SBC-STAT3 Rebooting

Issue Date: December 4, 2017

Product(s): SBC-STAT3, NB-ASCe, NB-VAV Series

Figure 1: 1k ohm resistor installed at NB controller

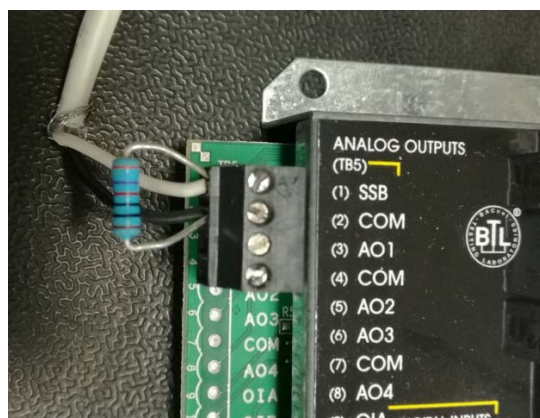
NB-ASCe and NB-VAV series controllers manufactured between January 2017 – October 2017 (affected date codes 0117-4217) and fitted with a ST Micro LM317 SOIC voltage regulator may cause the SBC-STAT3 to continually reboot. The frequency of rebooting worsens as the AC supply voltage to the controller is above 26VAC.

Findings: On affected controllers, when the control voltage (typically a 24VAC power control transformer) powering the controller exceeds the recommended tolerance (22VAC to 26VAC) as specified by American Auto-Matrix in the controller User Manual, the data transmission of the SBC-STAT as read and recorded by the controller is corrupt and eventually causes the controller to reset the SBC-STAT bus. Visually, the SBC-STAT values will disappear, and then reappear when the SBC-STAT has rebooted.

To rectify affected installed controllers, American Auto-Matrix recommends the use of a 1kohm +/-5% resistor connected across the SBC-STAT terminals (SSB(1) and COM(2)) at the affected controller. Alternatively, the same resistor with an extension wire can be installed across the terminals (R and C) at the SBC-STAT itself. Either one, **but not both**, of these options will rectify the issue.

For any affected controllers, that you may have in stock or inventory that are still newly boxed in original packaging, please contact Inside Sales for a free warranty exchange. All shipping charges will be borne by American Auto-Matrix. For units that have already been installed and are affected as per this bulletin, American Auto-Matrix recommends the installation of a 1k ohm +/- 5% resistor across the SBC-STAT bus terminals of the affected controller as per Figure 1.
